PEDESTRIAN MASTER PLAN

WORK SESSION #2

The Planning Board will discuss public testimony on the *Pedestrian Master Plan*, both oral and written, received before the closing of the public record on April 6, 2023.

April 20, 2023

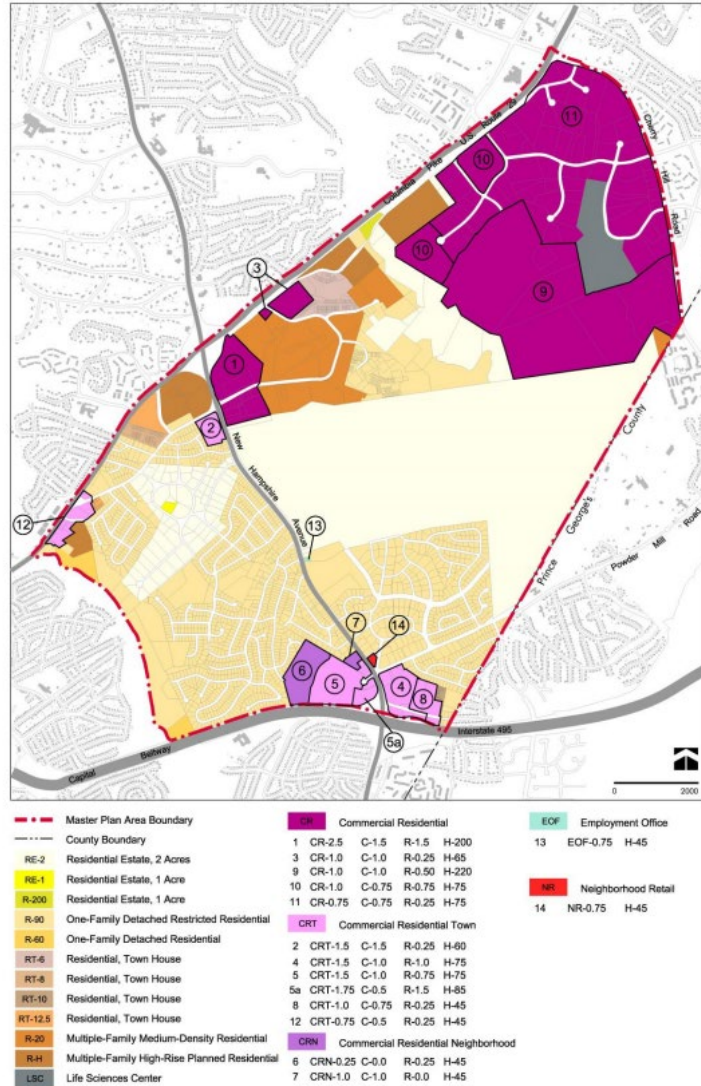
FARs here tend to only be between 1.0 to 1.5, and the development we've been seeing has been extremely suburban in nature.

Planning Staff Response: Disagree. While Planning staff agrees that changes are needed to the CSDG area designation for the Life Sciences Center, it is appropriate to defer decisions about the area type designation to the ongoing Great Seneca Plan: Connecting Life and Science, which is anticipated to be approved by the County Council in 2024.

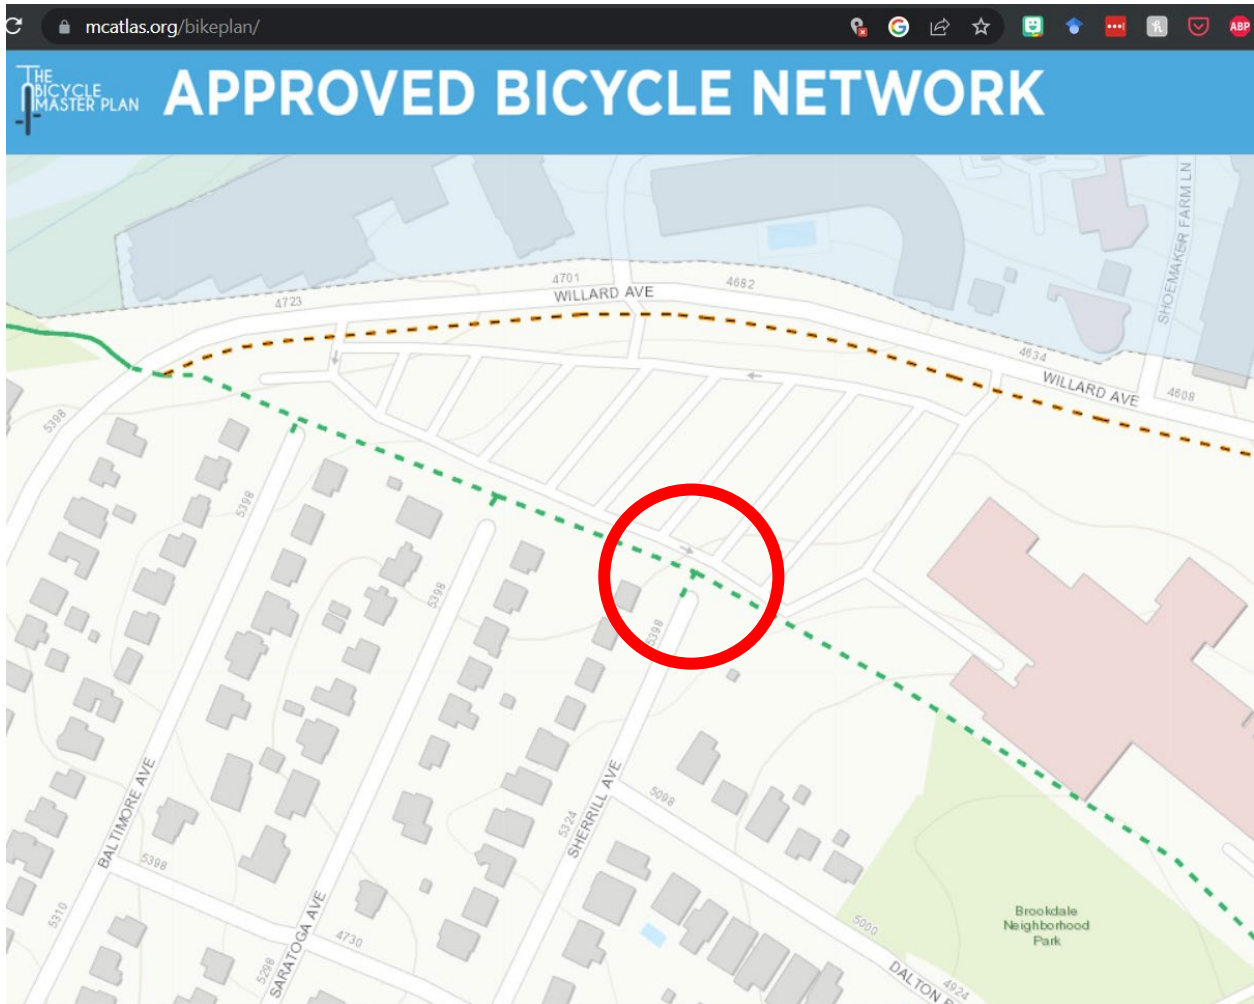
MCDOT is in the process of designing a bridge over the stream at this location, which would make the use of this corridor much more accessible year-round and in different weather conditions.

While steep slopes make it challenging to ultimately provide a trail connection between Kersey Road and Auth Lane that meets ADA standards, formalizing this connection as some sort of maintained pathway will make walking easier and safer for pedestrians of all ages and abilities.

At this point, with the design process in motion, Planning staff defers to MCDOT about the feasibility of this connection. If MCDOT finds the project infeasible or inadvisable, the County Council could remove this recommendation from the plan.
